FINAL FOR REVIEW
SEPTEMBER 28, 2012

I-75 NORTH BOUND AUXILIARY LANES
HENRY COUNTY

REINFORCED EARTH RETAINING WALL

WALL 2 ELEVATION

WALL 2 ELEVATION – FRONT FACE

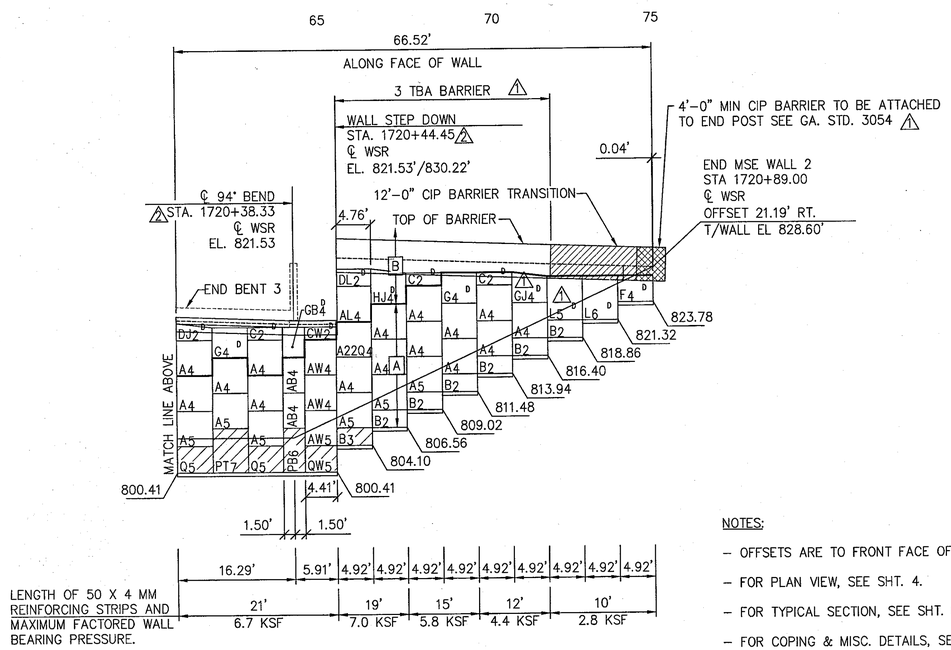
AFTER STAGE A, A WAITING PERIOD OF 30 DAYS SHALL BE OBSERVED PRIOR TO BUILDING STAGE B IN ORDER TO ENSURE THAT THE BEARING CAPACITY OF THE SOIL WILL BE SUFFICIENT TO SUPPORT THE MSE WALL. OWNER'S GEOTECHNICAL ENGINEER MUST APPROVE THIS STAGED CONSTRUCTION OR PROPOSE AN ALTERNATIVE.

REVISIONS	BY	DATE
REVISED BARRIER CALLOUT	SLM	10/12/12
REV. BEND LOC. PER MAA COMMENTS & ADDED STAGE CONST. LINES	VG	11/28/12

Approved in general. Details not checked. This approval shall not relieve the Contractor of any responsibility for conformity with the contract Plans and Specifications.
